**SAFETY RECALL NOTICE TO AFTERMARKET DISTRIBUTORS  
JANUARY 2004**

**"Platinum Series" brake drum cast date codes covered in this recall:**

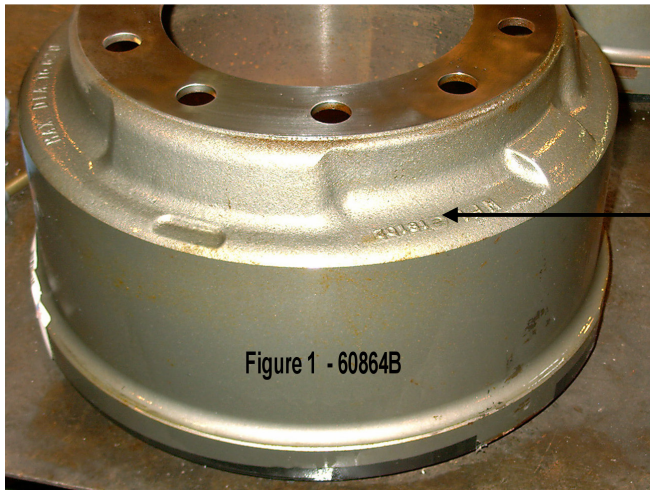
Cast date codes from 017-01 to 273-02 (Julian style date) are covered in this recall. Reference Figures 1 & 2 for cast date location.

1. You should inspect your inventory for "Platinum Series" brake drums with suspect cast date codes as described above. Drums found in inventory with cast date codes covered in this recall should be returned to Webb immediately on a Return Goods Order.
